# 2026 ルール変更・ローカルルール解説

2026 Rule Changes & Local Rules

- 目的 / Purpose  
2026年大会機械技術車検審査に向けたルール変化点・ローカルルールの周知と解説  
Notification and explanation of rule changes and local rules for the 2026 FSAEJ Technical Inspection (Mechanical Part only)
- 解説について / About Explanations
  - 関連項目ごとにまとめて解説 (関連するLocal Rulesも含わせて解説)  
Explanations for each related item (including related Local Rules)
  - “allowed” -> “permitted” のような意味が変わらない変化点は省略する  
Omit changings that do not change the meaning, such as "allowed" -> "permitted"
- 2026 FSAE Rules全体の解説は行わない  
No explanation for not changed items in 2026 FSAE Ruled
  - 変化点以外のFSAE Rulesに関しては2025年のルール解説を参照のこと  
Refer to 2025 Rules Explanation for not changed items.

### J2026-V-01 Wheel Restrictions

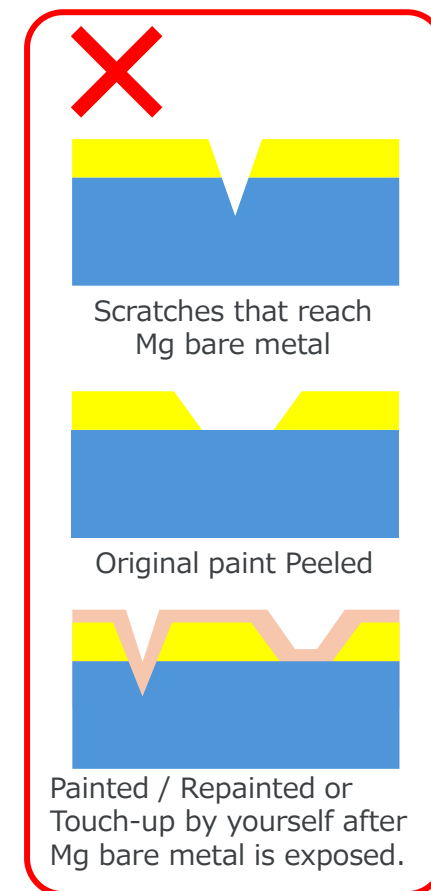
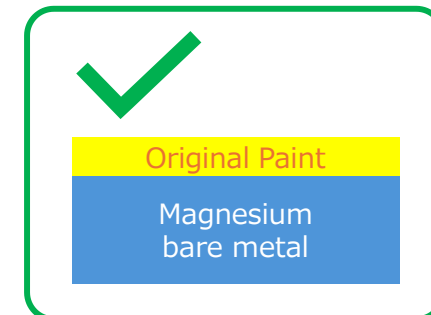
- **入手時期と有効期限内であることを証明するEvidenceの提示が必要**
- **一度でも地金が露出したマグネシウム製ホイールの使用は禁止**

(車検通過後のタッチアップは当年大会に限り許容 次年度以降使用不可)

他の材質のホイールも危険と判断される場合は使用不可

**使用不可と判断されたホイールは大会期間中車検にて預かる**

ASEは海辺であり、腐食性が高い材料の使用は不適

マグネシウムの塗装には専用設備と専用の塗料が必要 → 一般での塗装は非現実的

- Magnesium wheels MUST be proven by **the evidence that describes the purchase date and that in service life.**
- Magnesium wheels **that have had the bare metal exposed even once MUST NOT be used.** Touch-ups after passing inspection are permitted only for the current competition.
- Wheels made of other material also may be prohibited if judged dangerous.(IN.1.2.2)
- **Officials will impound any non approved wheels until the end of the competition.**

REPLACE THIS EXAMPLE WITH YOUR OWN CAD  
F.3.3.1, F.3.4.3 - HOLES OVER 4mm, STEERING RACK PASS THROUGH  
INSERT, OUTSIDE COLLAR, OR PLATE REQUIRED

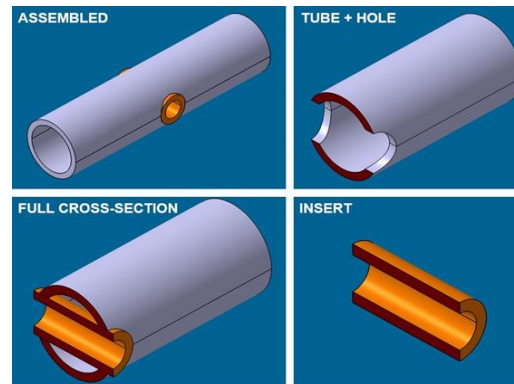
- Insertの肉厚は元のTubeの肉厚よりも厚くなくてはならない
- Insertの外径は元のTubeの外径か、四角Tubeの場合は2面幅よりも小さくなくてはならない

- Equivalence of the Welded tube and reinforcement must be shown to the original Non Welded tube in the SES
- Welded inserts must use a wall thickness greater than the original Non Welded tube
- Welded Inserts must use an outer diameter less than the original Non Welded tube diameter or square side

F.5.11.2 External Items may be mounted on the outside of the Main Hoop or Main Hoop Brace tubes if the mount is one of the two:

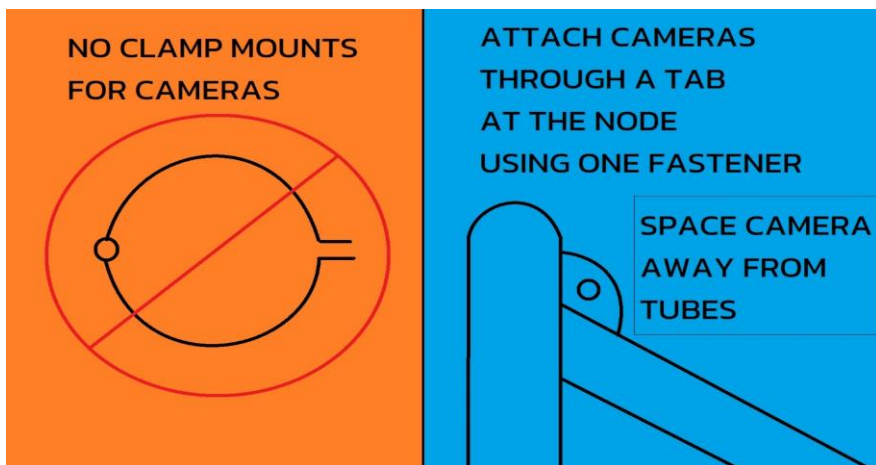
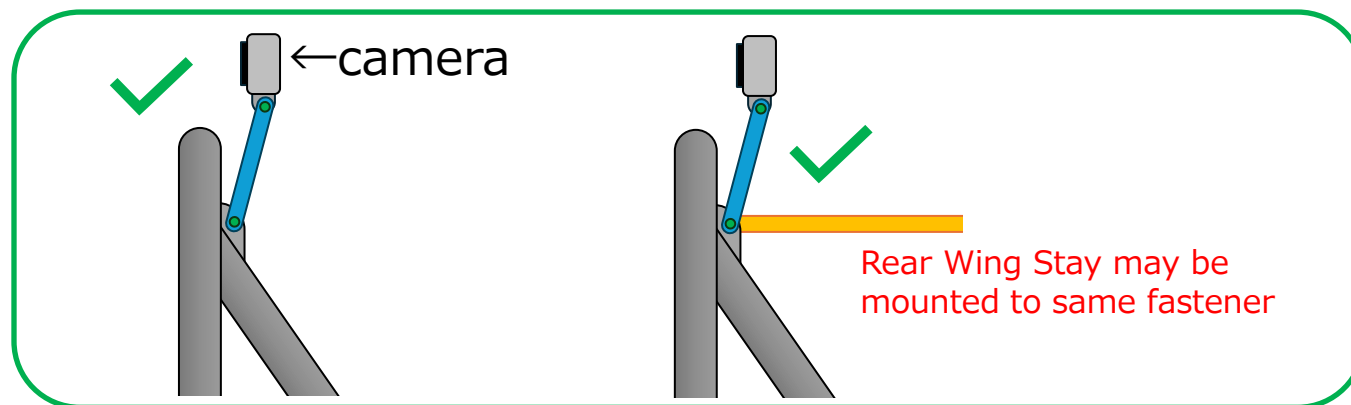
F.5.11.2a Tabで回転自在に取り付けるよう指定

F.5.11.4 Suspensionの取り付けも対象化

CameraのMH/MHBへの取り付け ⇒ External Itemに該当  
Cameras Mounted to MH/MHB are "External Items"

- With tabs located at the Main Hoop to Main Hoop Brace node and is rotationally free about an axis
- Above additional bracing meeting **F.3.2.1.o**, with calculations that show the mount will fail below the permitted load as calculated by the SES

F.5.11.4 Mounts for engine, motor, suspension or Tractive Battery Pack must not attach to the span of the Main Hoop Braces or Main Hoop above other tube nodes or composite attachments

F.6.4.4 The Upper Side Impact Member must:

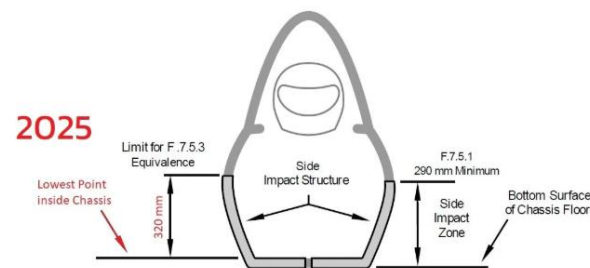
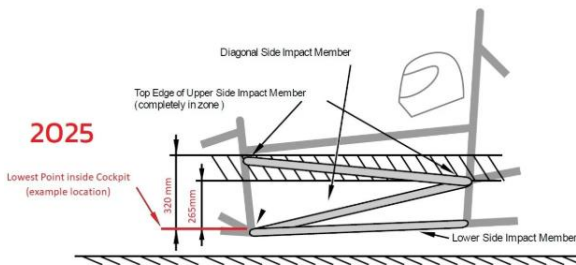
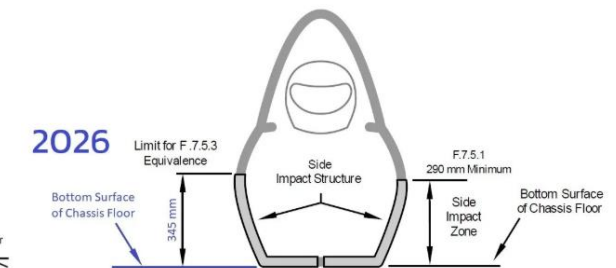
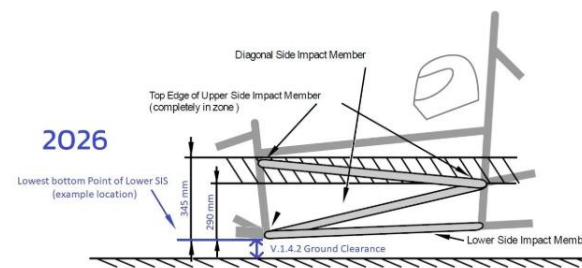
参照点がLower Side Impact Member / SIS Floor(Monocoque) 上面最下点から下面最下点に変更  
Reference Point is changed from top surface to bottom of lower SIS member / Floor(Mono)

合わせて各寸法が+25mmされた  
Then, each height is +25mm

Lower SISがΦ25.4mmのTube Chassis、SIS Floorの厚さが25mm以下のMonocoque chassisへの影響軽微  
Few effect on a lower SIS of Φ25.4mm or SIS floor thickness of 25mm or less(Mono)

- Connect the Main Hoop and the Front Hoop.
- Have its top edge entirely in a zone that is parallel to the ground between 290 mm and 345 mm above the lowest point of the bottom of the Lower Side Impact Member

F.6.3.3 The Front Hoop Braces must be constructed to protect the driver's legs and should extend to the structure in front of the driver's feet.

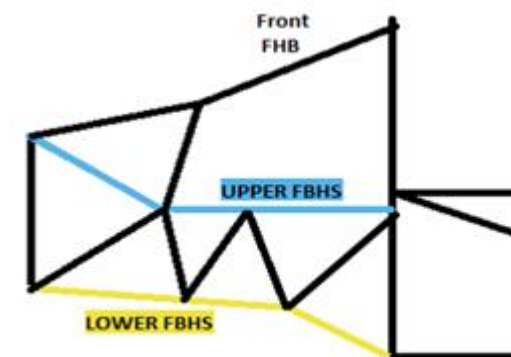
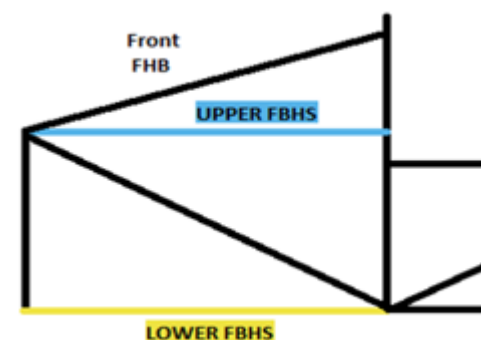
FHBの接続先が明確化された  
FHB connection destination has been clarified

設計への影響なし  
No effect on Frame Design

F.6.3.3 The Front Hoop Braces must extend to one of the two:  
a. The Front Bulkhead  
b. A triangulated structural node

Edge Dist. vs Thickness requirement(15kN/Attach)

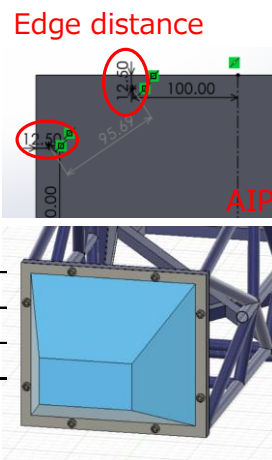
AIP Bolt mount時のTearout強度が別で規定された  
Tearout Strength is redefined for bolt mounted AIP

元々15kN/Attachment を満たすには  
To satisfy 15kN/Attachment

注：  
STD-Form(95kN)に  
Steel t1.5 AIP centerline mount で8本留め(63kN) では不足  
(A5052-O t4も不可)

- b. Bolted joints
  - Using no less than eight 8 mm or 5/16" minimum diameter **Critical Fasteners, T.8.2.**
  - The distance between any two bolt centers must be 50 mm minimum.
  - Each bolt attachment must have pullout and bending capabilities of 15 kN
  - Bolt tearout capability must meet one of the two:
    - Each bolt attachment has tearout capability of 15 kN
    - The total tearout strength of the mounting (not individual bolts) must be more than the attachment strength of the Impact Attenuator in **F.8.5.3.b**

トータルでF.8.5.3bの荷重を満足すること  
The total tearout strength must be more than load in F.8.5.3b

F.10.5.2 Accumulator Containers must:

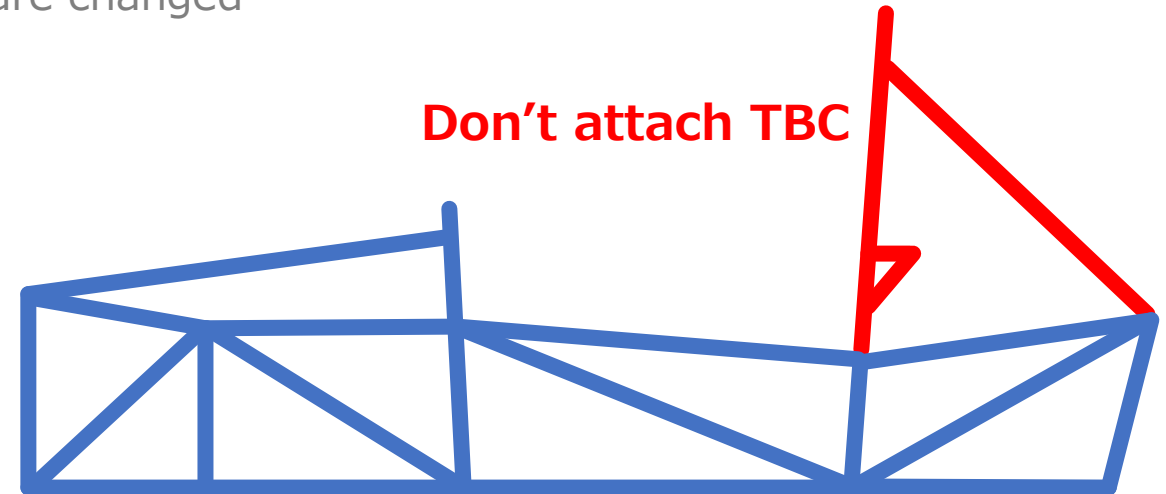
Tractive Batter ContainerのAttachment取り付けの変更

Tractive Battery Container Attachment points to structure are changed

- a. Attach to the Major Structure of the chassis
- b. Use a maximum of two attachment points on a chassis tube between two triangulated nodes
- c. Not attach to the Shoulder Harness Mounting Bar or Braces, Main Hoop Braces or Main Hoop above other tube nodes or composite attachments
